# TCG 01-G & TCG 02-G Ethernet Release Notes

VERSION 3.21r3 (November 2017)

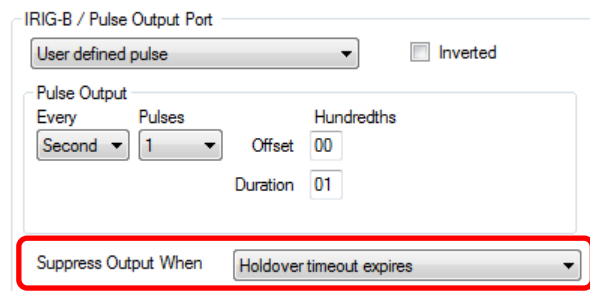
Added the ability to independently suppress individual outputs based on inaccuracy threshold or holdover timeout. When “holdover timeout expires” is selected, that particular output will stop providing a time signal when the clock is out of sync and the specified holdover time has expired.

When “Inaccuracy threshold is exceeded” is selected, that particular output will stop providing a time signal when the clock is out of sync and the reported inaccuracy has exceeded the specified maximum inaccuracy. When “Never” is selected, that particular output will continue to provide a time signal even when the clock is out of sync.

This applies to the following ports:

- Configurable IRIG-B / Pulse output ports (P2, P3, P4 pin 1)
- P4 serial string output port
- P5 AM IRIG-B output port
- P11 configurable IRIG-B / Pulse output port (TCG 02-G M2 expansion)
- P9 configurable IRIG-B / Pulse output port (TCG 02-G M3 expansion)
